# New Hampshire Yankee

NYN-91157

Subject: Supplemental Submittal for the Radiograph Reinterpretation Program Completion Report

ENCLOSURE 1 TO NYN-91157  
SUPPLEMENTAL SUBMITTAL FOR THE RADIOGRAPH  
REINTERPRETATION PROGRAM COMPLETION REPORT

FIGURE #1

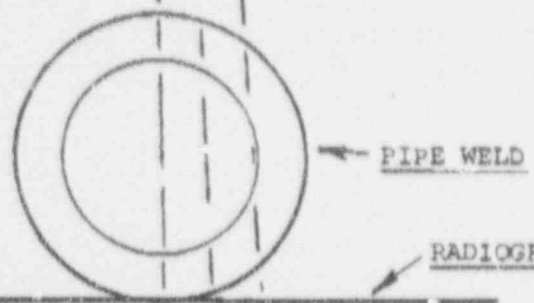
When pipe welds with relatively small diameters are radiographed using the double wall exposure and double wall view technique, (either elliptical or superimposed image) the effective composite through wall path the radiation passes through, radically changes as the distance away from the pipe center increases. (See Figure # 1).

If a typical radiographic technique produces an image with good contrast (beneficial in radiography in order to observe density changes resulting from small cross sectional thickness changes), the density variations as a result of this effective composite through wall path will be significant.

If a low contrast radiograph is taken, the result will be a more uniform density throughout the area of interest thereby minimizing the possibility of falling outside the code-required density range.

This rationale is not intended to provide an excuse for not complying with the Code but merely to point out the reason for the density variation problems. Increasing the number of exposures to achieve greater coverage would have been one solution.
